DOE-0162-03

**TRANSMITTAL OF RESPONSES TO THE UNITED STATES ENVIRONMENTAL
PROTECTION AGENCY AND OHIO ENVIRONMENTAL PROTECTION AGENCY COMMENTS
ON THE INTEGRATED ENVIRONMENTAL PLAN, REVISION 3A AND ASSOCIATED
CHANGE PAGES**

**RESPONSES TO EPA AND OEPA COMMENTS ON THE
INTEGRATED ENVIRONMENTAL MONITORING PLAN
REVISION 3A, DRAFT FINAL**

FIGURE 1 - COMPARISON OF MONTHLY THORIUM-230 FENCELINE CONCENTRATIONS
AND WPRAP OPERATIONAL DATA

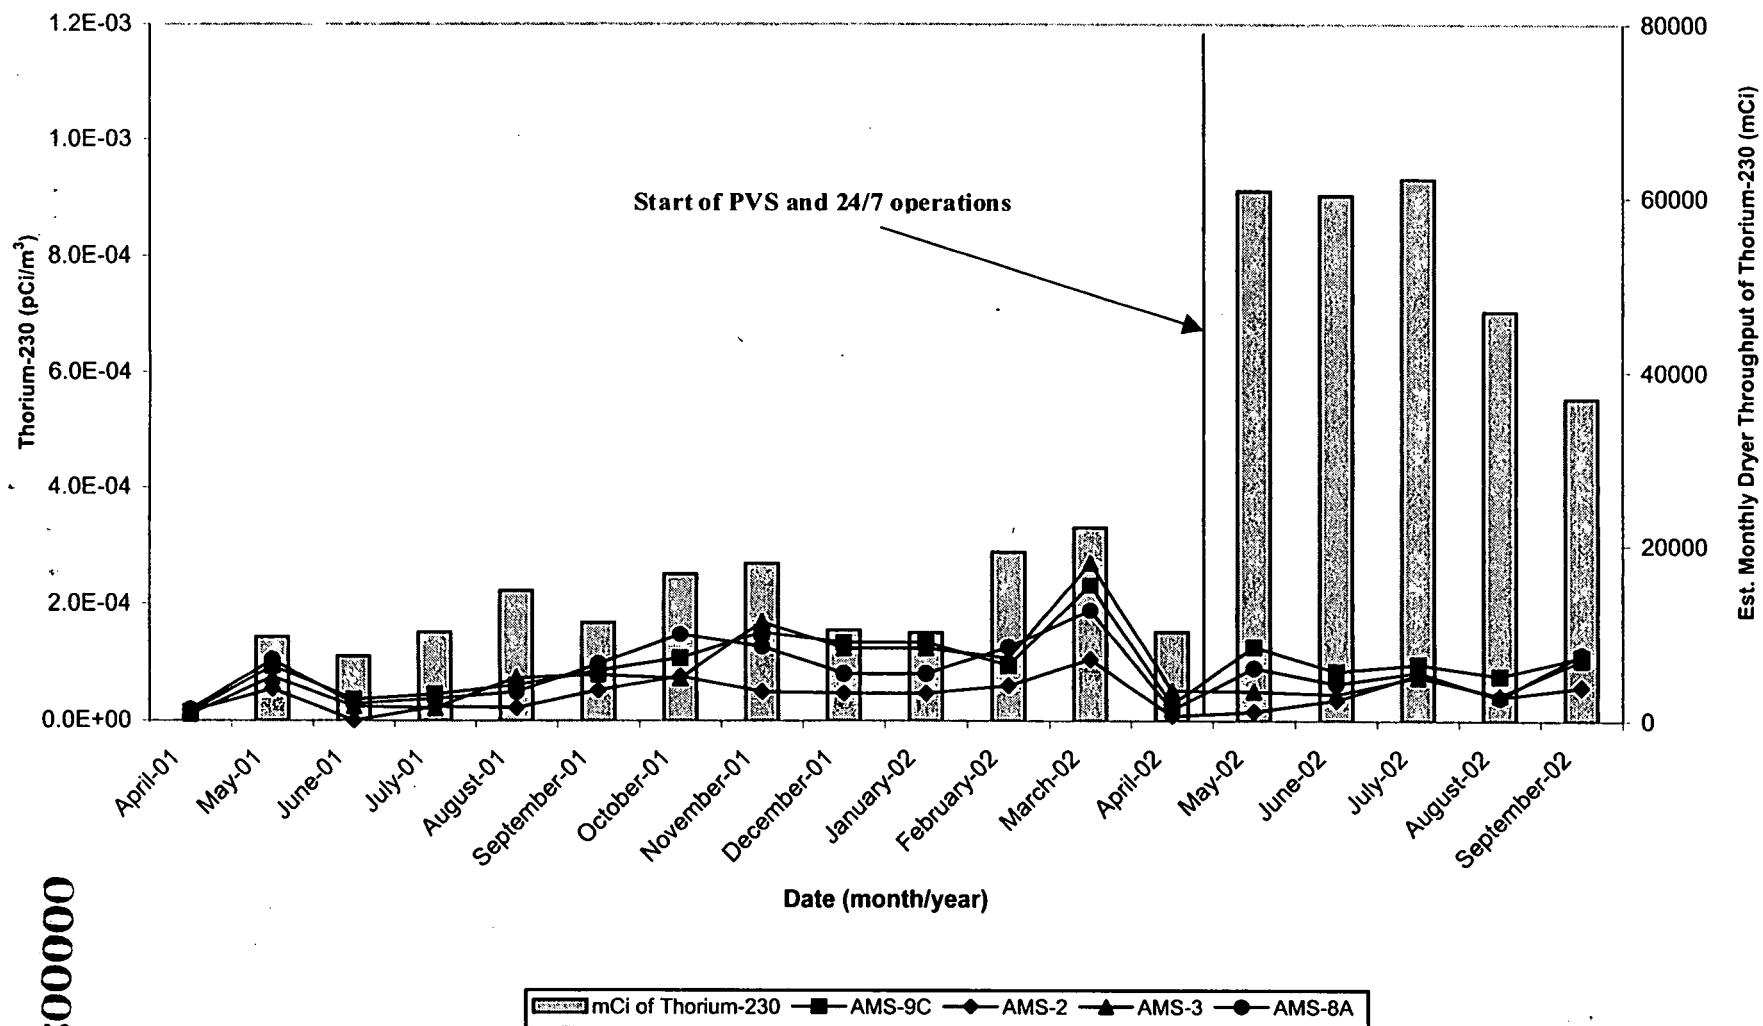
Comment: DOE proposes to reduce the frequency of thorium analyses from biweekly to monthly and to eliminate the monthly analysis during months when a quarterly composite filter is to be

analyzed. Although the IEMP lists several factors supporting this proposal, thorium 230 remains the most significant radionuclide in terms of its contribution to the measured fenceline dose. Reducing the thorium analytical frequency during a period when cleanup activities are accelerating (as discussed in Section 6.1) seems questionable.

In particular, thorium emissions associated with increasing the Waste Pit dryer production rate and beginning Silo 3 operations are of concern. The IEMP states that thorium 230 concentrations have remained comparatively stable as dryer throughput has increased, but the document should be revised to provide data supporting this claim (including project-specific monitoring results). If the data demonstrate stable thorium 230 concentrations, monthly thorium analyses may be appropriate during the period before Silo 3 waste removal activities begin. At that point; however, biweekly thorium analyses should resume until DOE can demonstrate that Silo 3 activities are not having a significant effect on thorium concentrations in air.

The following figure (Figure 1) provides a comparison between the estimated amount of thorium-230 processed by the WPRAP dryers and the corresponding thorium-230 concentrations at four fenceline monitors (AMS-2, 3, 8A, and 9C) that are along the eastern site boundary and typically downwind from the WPRAP area. As shown in the figure, during the period of operations from 10/19/00 through 4/21/02, there were periodic spikes in the thorium-230 concentrations at monitors along the eastern fenceline. These short-lived increases have been attributed to several factors including; higher thorium-230 concentrations in the dryer feed material, periodic excursions in the moisture content of dryer output (e.g. during dryer re-start after maintenance), and meteorological conditions.

DOE agrees to re-evaluate the frequency of fenceline thorium analysis prior to the start of the Silo 3 waste retrieval activities. It should be noted that biweekly thorium analysis is currently being performed at four project-specific environmental monitors located in the Silo area. The Silos Project Environmental Monitoring Plan (Fluor Fernald 2002) describes the location and analysis plan for these monitors. This plan was submitted for agency review as part of the Silos remedial design documents.

FIGURE 3-7. RE-INJECTION MODULE MONITORING
WELLS AND DIRECT PUSH SAMPLING LOCATIONS

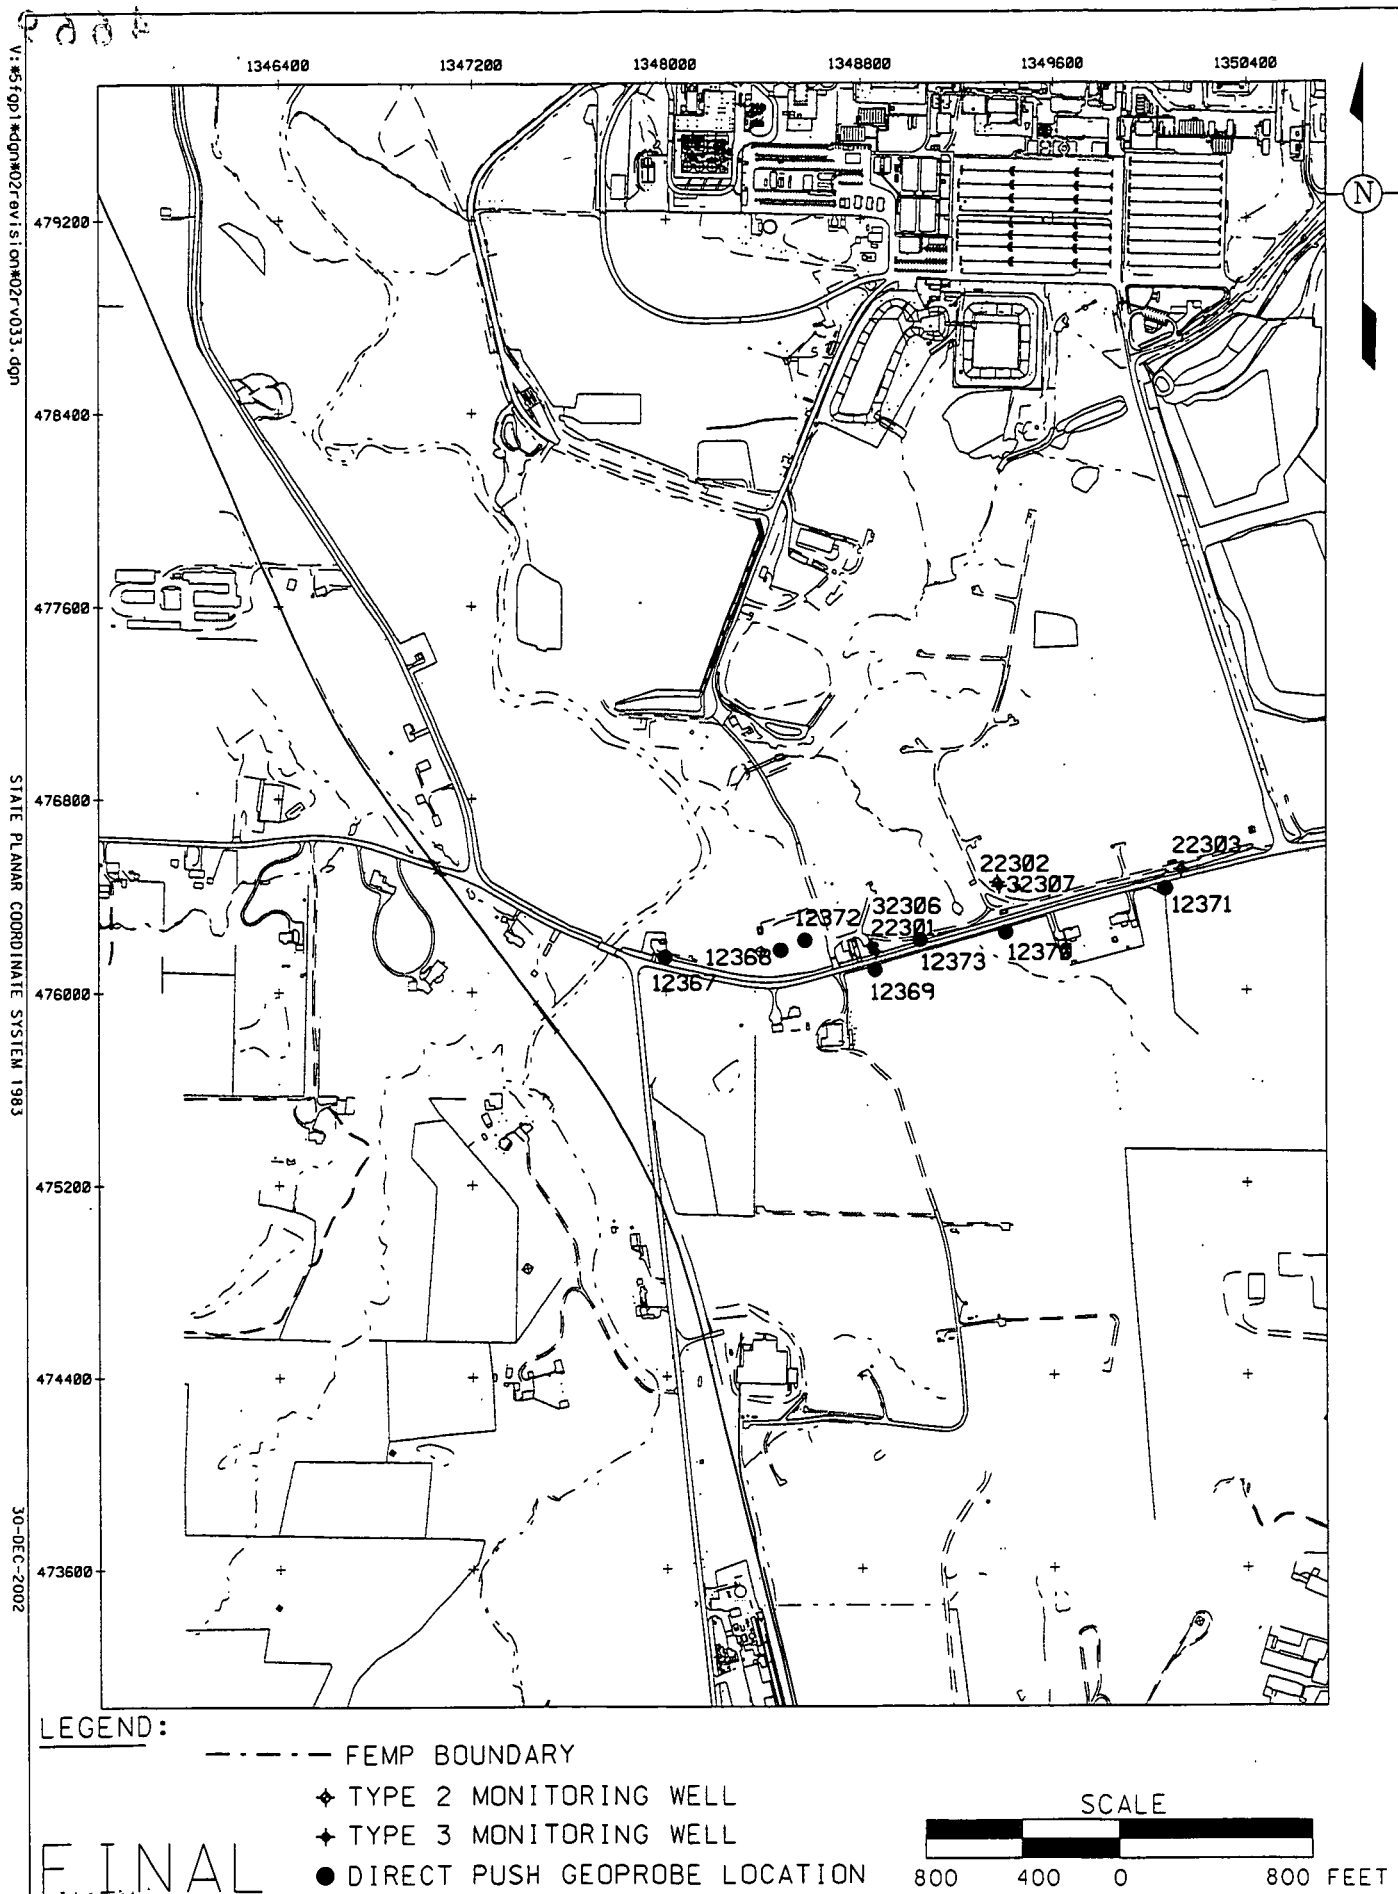
17. Commenting Organization: Ohio EPA Commentor: OFFO
 Section #: Figure 3-7 Pg. #: 3-39 Line #: Code: C
 Original Comment #: 8
 Comment: The symbol for the direct-push sampling locations is poorly reproduced in our copies of this plan and it cannot be distinguished from a filled-in circle.

Response: DOE agrees with the comment. Figure 3-7 has been updated with a filled in circle being used to locate direct-push geoprobe locations.
 Action: Figure 3-7 has been updated per response. The required change page to the IEMP (page 3-39) is provided as an attachment to this comment response document.

FIGURE 6-4. DIRECT RADIATION (THERMOLUMINESCENT DOSIMETER) MONITORING LOCATIONS

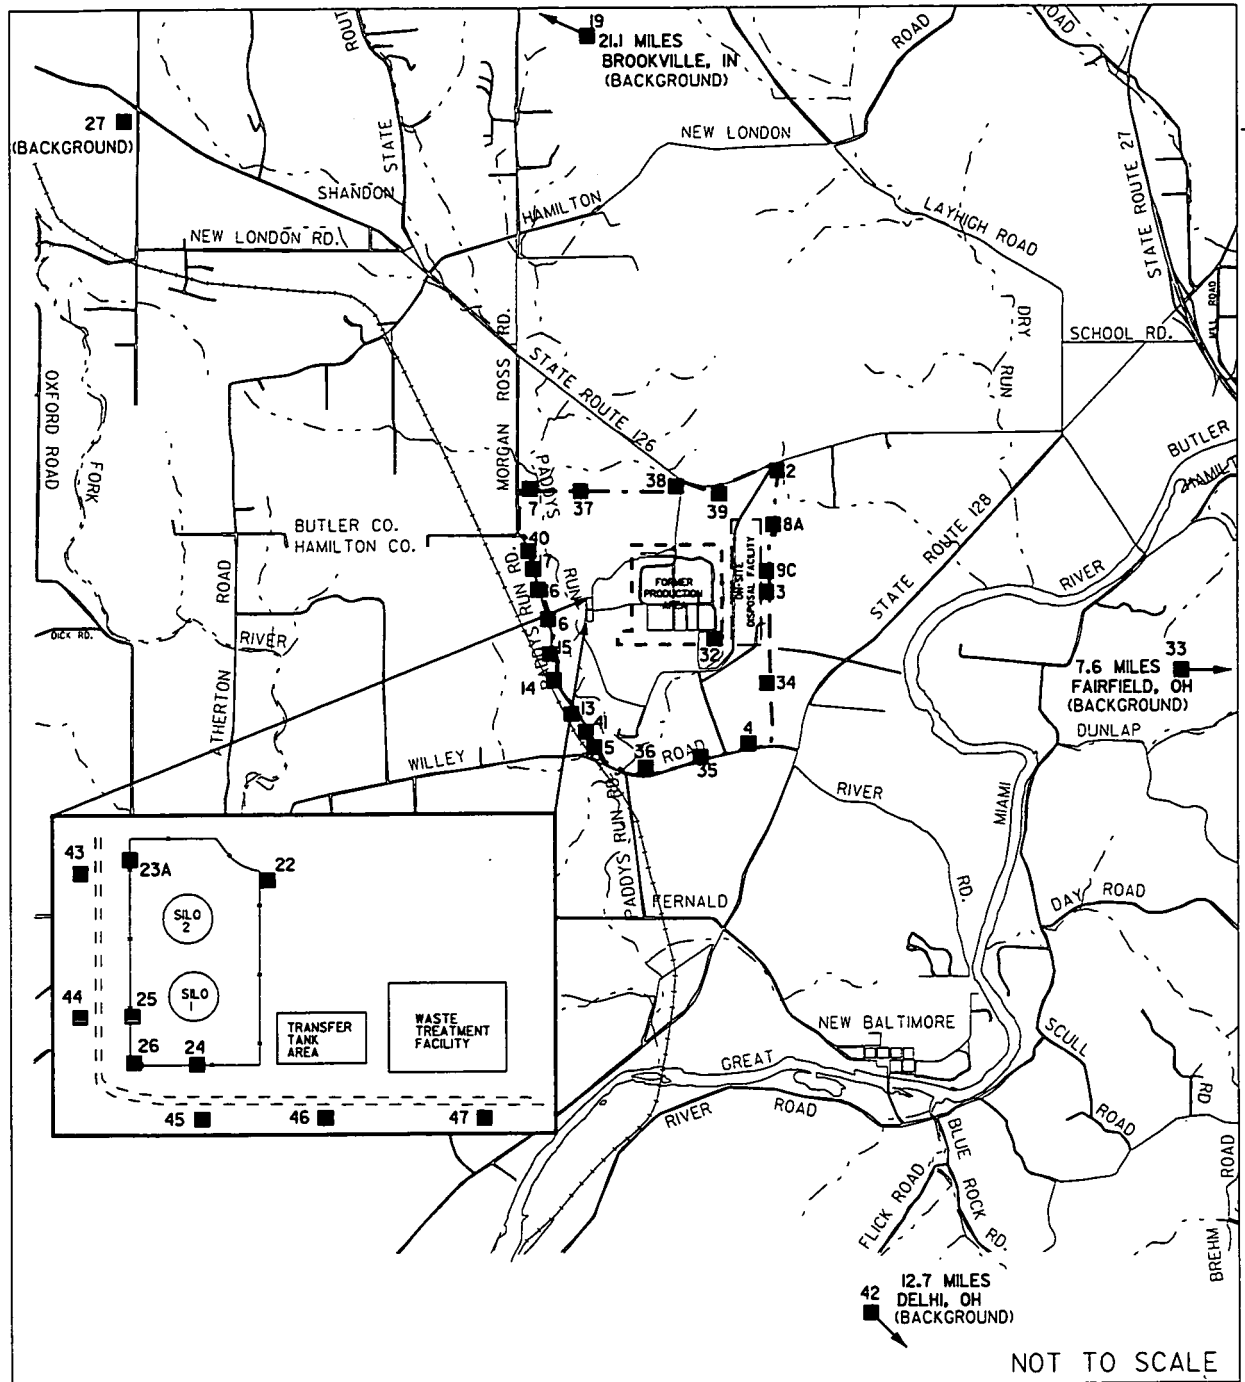
Comment: DOE plans to add five new direct radiation monitoring stations (locations 43 through 47) in the Silo 1 and 2 area. However, comparison of the new locations shown in Figure 6-4 with the updated wind rose shown in Figure 6-2 revealed that all five locations are predominantly upwind of Silos 1 and 2. A review of the data from the last four quarters

on the IEMP Data Information Site revealed that direct radiation levels tend to be highest at location 22, the location most likely to be downwind of the silos. The IEMP should be revised to (1) provide additional information on how the five new monitoring locations were selected and (2) explain why additional monitoring locations downwind of Silos 1 and 2 were not considered.

Response: In response to this comment, some technical details related to the IEMP direct radiation (x-ray and gamma) monitoring program need to be identified. Specifically, the environmental dosimeters used in the IEMP direct radiation monitoring program are not sensitive to the very small increase in direct radiation levels associated with the elevated ambient radon concentrations in the vicinity of the silos. Therefore, the response of the dosimeters is not affected by its downwind or upwind location with respect to Silos 1 and 2. The response of the dosimeters is strongly dependent on the distance between the dosimeter and the source of radiation. This, in part, explains why the dosimeter at location 22, which is comparatively close to Silo 2, tends to have the highest reading. The environmental dosimeters are capable of measuring the changes in direct (x-ray and gamma) radiation levels associated with radon concentrations in the millions of pCi/L, such as those that exist in the silo headspace. The dosimeters are also capable of measuring the direct radiation emitted from the waste material stored in Silos 1 and 2, beneath the bentonite layer.

Two of the five new monitoring locations (43 & 44) were selected based on the need to monitor direct radiation levels from the Silos 1 and 2 wastes as the berm is excavated. The excavation of the berm will change the radiation shielding in place around the Silos and may affect radiation levels at the fenceline. These locations will also serve as secondary monitoring locations in the event that Silo construction activity eliminates locations 23A, 24, 25, and 26. Three new monitoring locations (45, 46, & 47) were selected based on the need to monitor direct radiation levels from the Silo wastes and their associated high levels of radon as the wastes are transferred from Silos 1 and 2 to the transfer tank area, and eventually to the waste treatment facility. The location of these buildings within the Silos area is included in Figure 6-4 of the IEMP, Rev. 3A. More specifically, the new locations were selected to monitor the movement of these materials as it affects radiation levels at the site fenceline.

Action: The paragraph identified in the response has been added to Section 6.4.2.3. The required change pages to the IEMP (pages 6-21 through 26) are provided as an attachment to this comment response document. Note that the new text is specifically included on page 6-21; however, due to the amount of text added, additional change pages are necessary.
